RESPONSES TO COMMENTS

**DRAFT PHASE I RFI/RI WORK PLAN
INSIDE BUILDING CLOSURES
OPERABLE UNIT 15**

U.S. DEPARTMENT OF ENERGY

MAY 1992

Figure 2-6

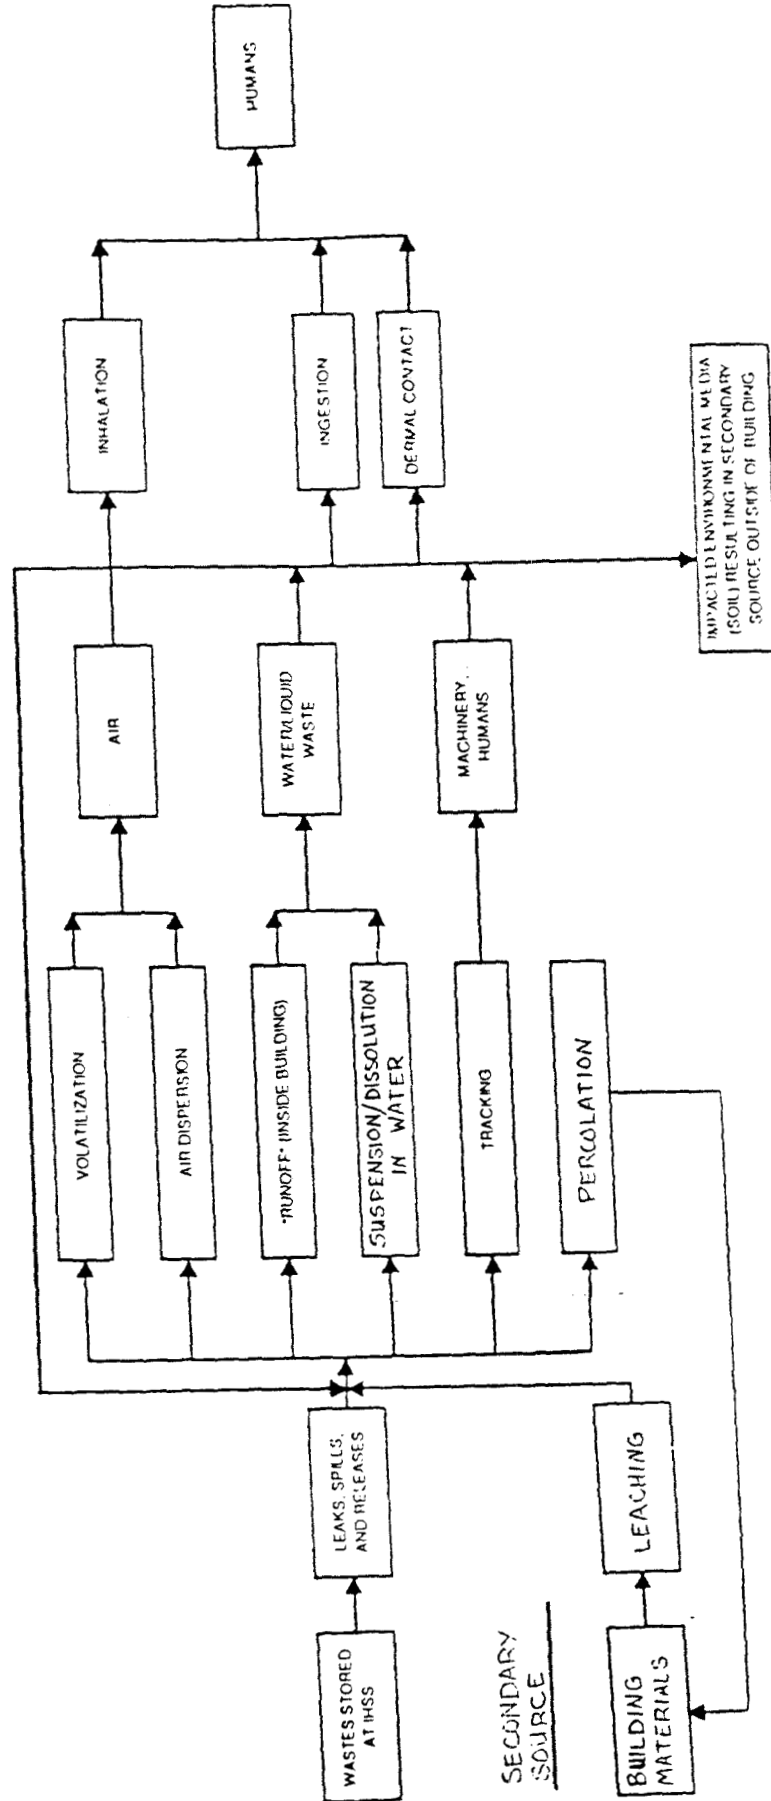
Figure 2-6: Revise the flow chart to more clearly show the conceptual model described in the text:

1. Identifying the two columns under "Release Mechanisms" as "Primary" and "Secondary" would add clarification.
2. Routing contamination from impacted environmental media back into inside-building pathways is misleading. It may be more appropriate to show a route from the various transport media to the secondary release mechanisms indicating that after transportation, contaminants could be re-released by

those mechanisms.

3. The second paragraph on page 2-33 describes "suspension and/or dissolution in water" as a secondary release mechanism for the Original Uranium Chip Roaster. This mechanism should therefore be added to the flow chart.

4. In section 8.1 on page 8.2, building materials are identified as a "relevant medium." The release mechanism which would likely deliver contaminants into building materials is probably more accurately termed "percolation" rather than "leaching." Once the building materials are contaminated, they would then serve as a secondary source. A "Building Materials" box should therefore be added in the source column under the heading of "Secondary Source." The release mechanism from building materials is "Leaching." From that point, contaminants could be released by the various secondary release mechanisms, transported primarily via water/liquid waste.

An accompanying revised diagram demonstrates these suggested changes.

Figures 2-3, 2-4:	The document has been modified as requested.
Figure 2-6:	Figure 2-6 has been modified as requested.
Section 3.0:	The document has been modified as requested. Clean Closure Performance Standards (Section 265.111 of the Colorado Hazardous Waste Act) will serve as the Applicable or Relevant and Appropriate Requirements (ARARs) for OU15.
Section 4.1.3:	The document has been modified as requested.
